# UNITED STATES PATENT AND TRADEMARK OFFICE

APPLICATION NO.	FILING DATE	FIRST NAMED INVENTOR	ATTORNEY DOCKET NO.	CONFIRMATION NO.
09/910,872	07/24/2001	Yasumichi Kuwayama	Q65548	4044

# Office Action Summary

Fig. 1

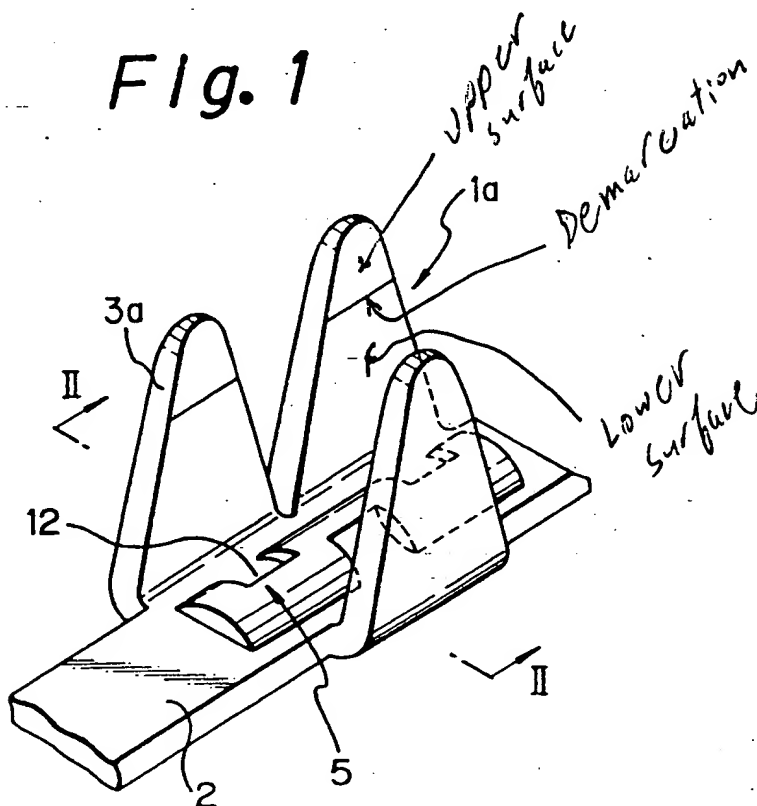
6. Claims 1, 2, 4, and 6-10 are rejected under 35 U.S.C. 102(b) as being anticipated by Murakami. Per claims 1, 4, 6, Murakami discloses an electric connecting terminal (figures 1-2) capable of being connected to a flat circuit body comprising a plane portion (at 2); a pair of piercing portions 3 erected from opposite side edges of the plane portion adapted to penetrate through a coating and a conductor of the flat circuit body and fold tips thereof in such a direction as to approach each other; and a "taper surface" for gradually reducing a thickness of the piercing portion provided on an internal surface of each piercing portion. Note that as disclosed in Murakami figures 1 and 2, the internal surface of portion 3 is made of two planar surfaces where the surface toward the tip of

the portion 3 is beveled with respect to the lower surface, this being the same structure as disclosed in applicant's application as the "taper surface." (see attachment).

7. Per claims 2, 10 an external surface opposed to the internal surface of each piercing portion is provided with a taper surface for gradually reducing the thickness of the piercing portion (see figure 2).

8. Per claims 4, 8, Murakami discloses a portion which has a constant width adjacent to the plane portion (see attachment).
